FIHSER-PRICE 71924 RC DASH RECEIVER SCHEMATIC (RF SECTION)

Title
71924 RC DASH RF SECTION - FINAL RELEASE

FISHER-PRICES 71924 RC DASH RECEIVER SCHEMATIC (MICRO-CONTROLLER SECTION)

Title
 71924 RC DASH MICRO-PROCESSOR SECTION - FINAL RELEASE

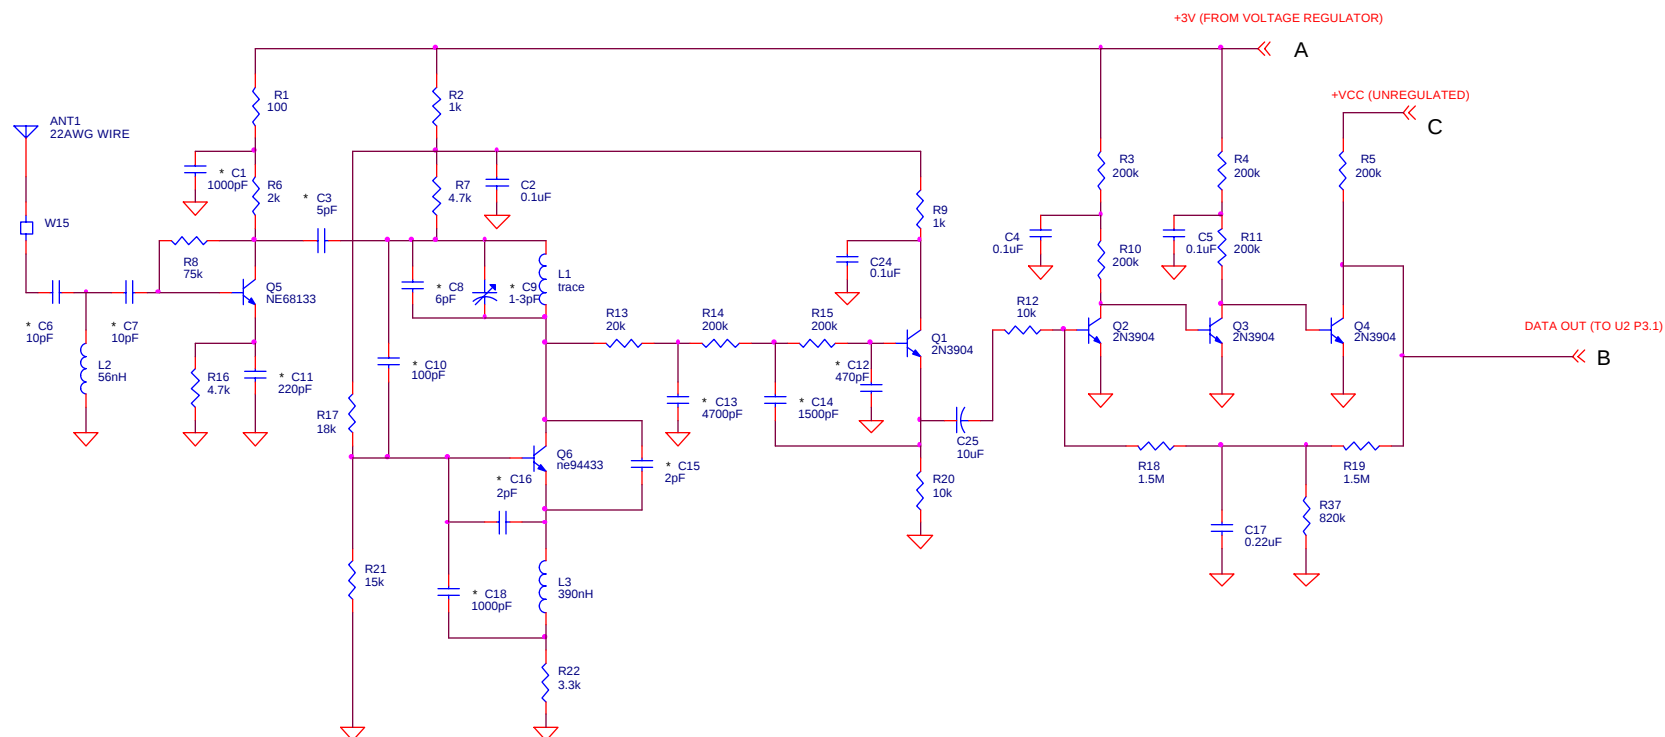
CHANGES:
R7 From 10k To 4.7k
R17 From 24k To 18k
C8 From 8pF To 6pF
R37 From 1.5M To 820k
Q4 Collector moved to Unregulated Voltage For Logic Leveling
C25: 0.1uF to 10uF (low leakage electrolytic)
C17: 0.1uF to 0.22uF ceramic

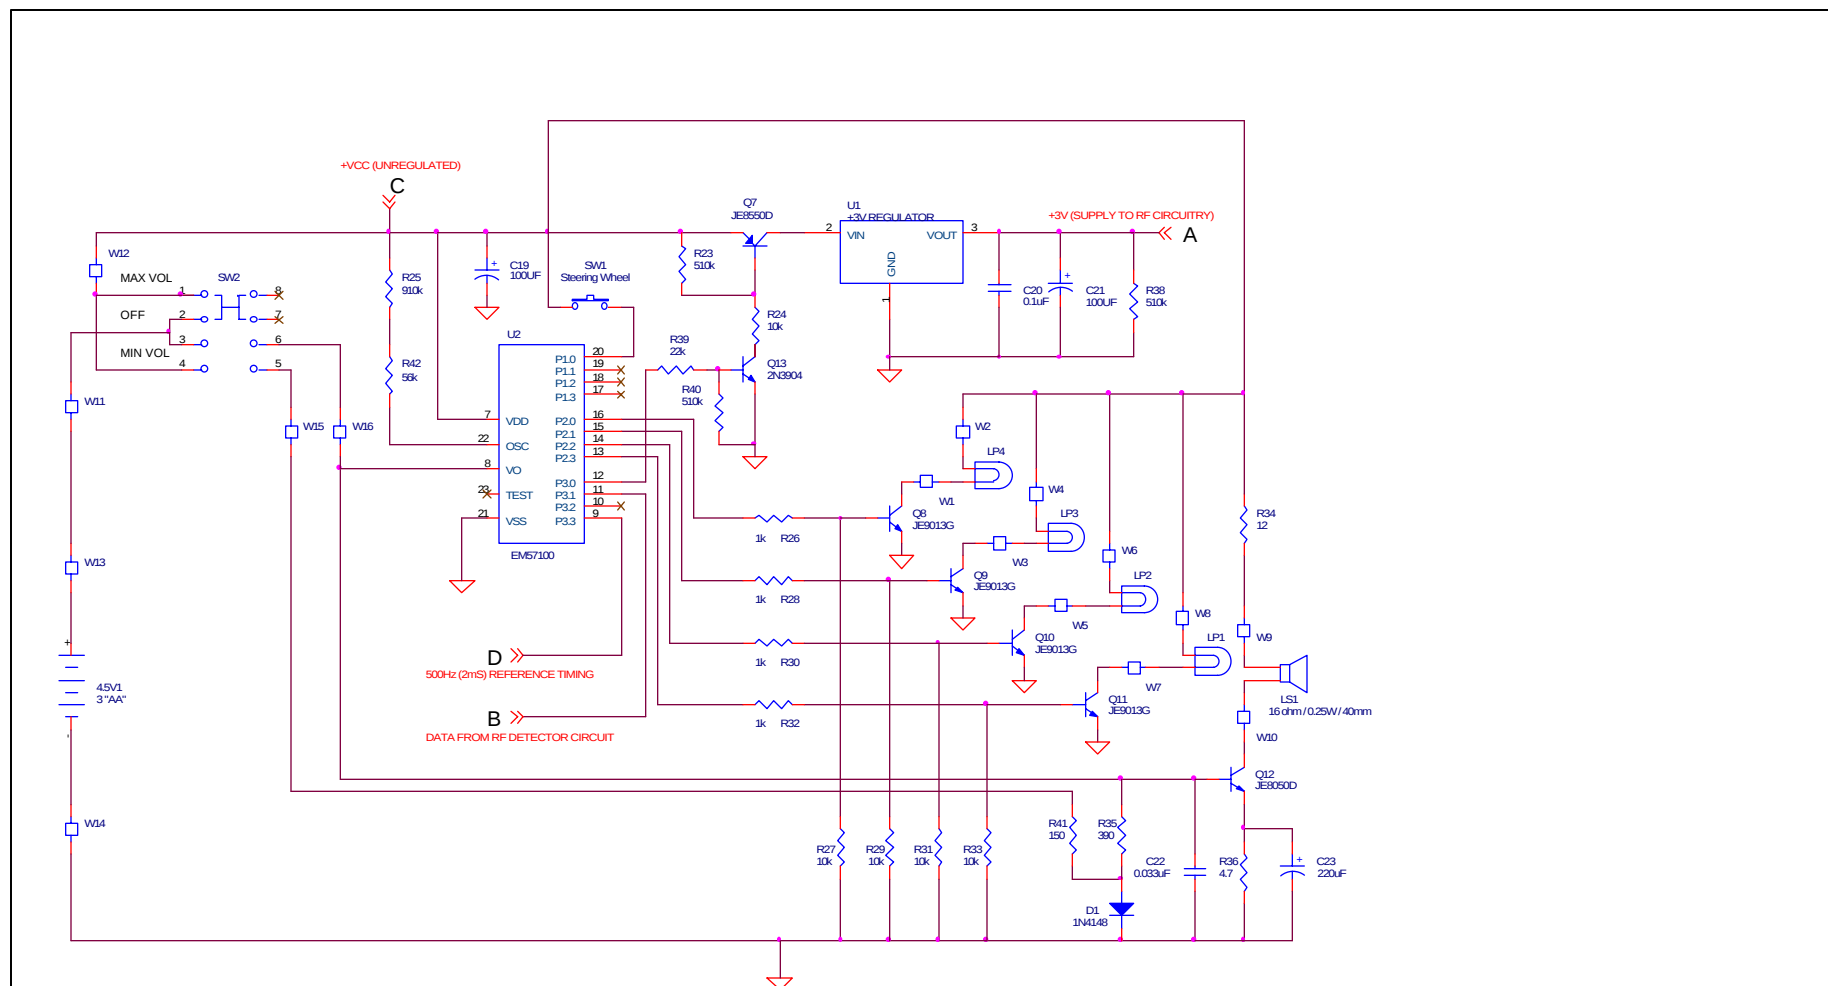
R23 10k to 510k, R24 1K to 10k
 Port 2 Changed LP1- LP4, Port 3 changed Pass Xter Predriver, RF DATA IN
 LS1 Speaker Size From 2.25in (57.15mm) To 1.57in (40mm).
 R25 From 1M to 910k, R42 From TBD to 56k.

R39Q13, R39, R40 to solve port impedance (KEYB)
 SW2, 2P3T (On/Off/Volume)
 R41(volume reduction), R42(line master clock adjustment if necessary)
 R35 From 150 To 390
